## **Rationale for the proposed amendments to Regulation No. 110 (CNG/LNG vehicles) (Based on Informal Document GRSG-111-02-Rev.1)**

### **Proposal - Alignment with ISO 11439:2013 - Proposed Revisions to:**

Regulation No. 110

Craig Webster, P.Eng.  
Convener – ISO TC 58/SC 3/WG 17 for the ISO 11439 Standard

Figure H.1 - Cylinder orientation and layout of exposure areas

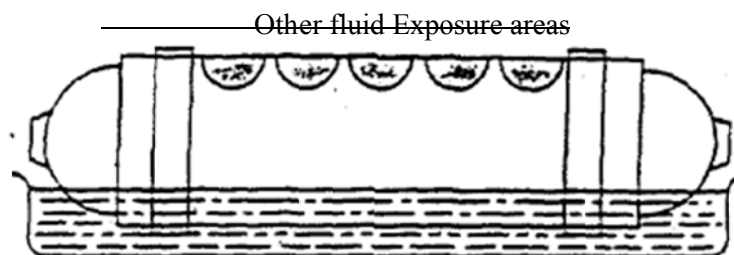
~~Cylinders will be tested horizontally and nominally divided along their horizontal centreline into "upper" and "lower" sections. The lower section of the cylinder will be alternatively immersed in road salt/acid rain environment and in heated or cooled air.~~

The upper section will be divided into 5 distinct areas and marked for preconditioning and fluid exposure (see **Figure H.1**). The areas will be nominally 100 mm in diameter. The areas shall not overlap on the cylinder surface. While convenient for testing, the areas need not be oriented along a single line, but shall not overlap the immersed section of the cylinder.

*The immersion part of the test was eliminated in ISO 11439 as the concentrated exposures to the 5 chemicals would provide a more severe test condition.*

Figure H.2

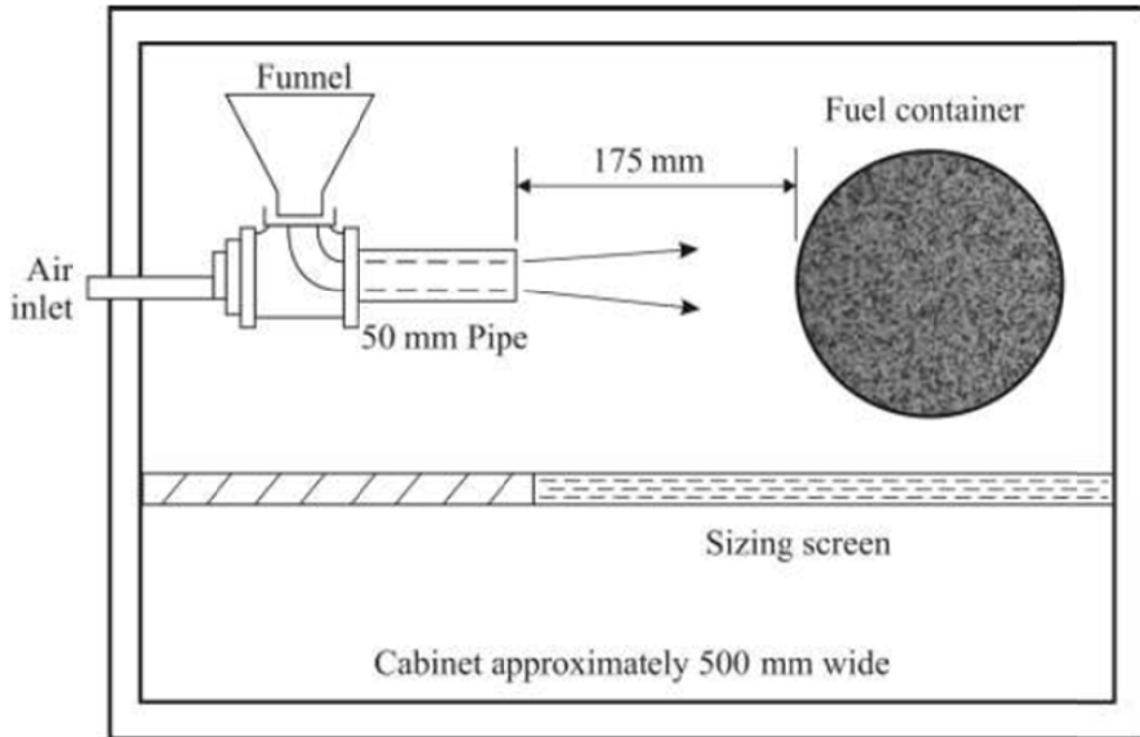
~~Machine constructed according to the design specifications shown in Figure H.2. This procedure for operation of the equipment shall follow that described in ASTM D3170, Standard Test Method for Chip Resistance of Coatings with the exception that the cylinder may be at ambient temperature during gravel impact;~~

~~Alluvial road gravel passing through a 16 mm space screen but retained on a 9.5 mm space screen. Each application is to consist of 550 ml of graded gravel (approximately 250 to 300 stones).~~

*It was found in testing that the gravel impact had no apparent effect on the integrity of cylinders, or any protective coating – the pendulum impact was a much more severe test of a coating.*
